**FINAL PRODUCT/PROCESS CHANGE NOTIFICATION #16757**Generic Copy

**TITLE:** Qualification of ON Semiconductor's Seremban Site as the die sales assembly site for Seoul Semiconductor Company Ltd (SSC)'s die sales devices

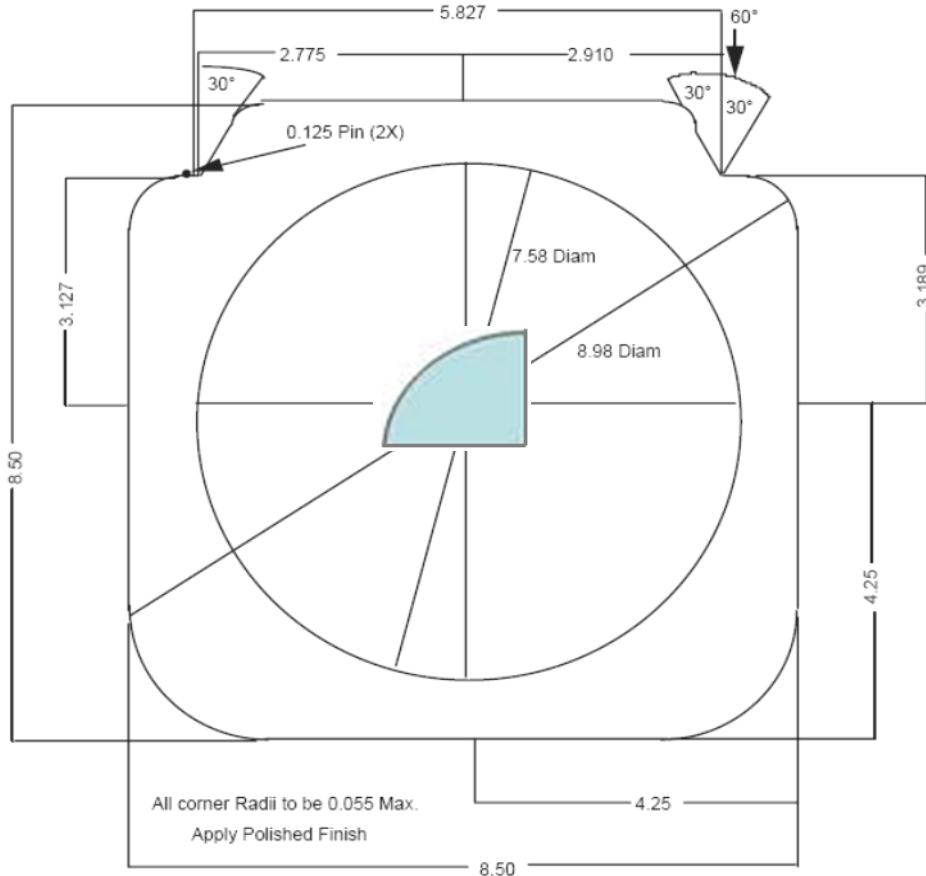
ON Semiconductor is pleased to announce that SSC wafer sales devices are now qualified for production (saw, inspection & packaging) at ON Semiconductor's Seremban facility.

Upon expiration or approval of the Final PCN, devices may be supplied from Seremban facility.

The devices have previously been manufactured at SAWTECH and CEI. Devices are now qualified to run at ON Semiconductor Seremban facility for saw, inspection & packaging. No changes to wafer fab source & device electrical performance as a result of this die sales assembly site qualification.

Packaging method will be changed to quartered sawn wafer mounted on mylar & metal ring, in flexible film frame.
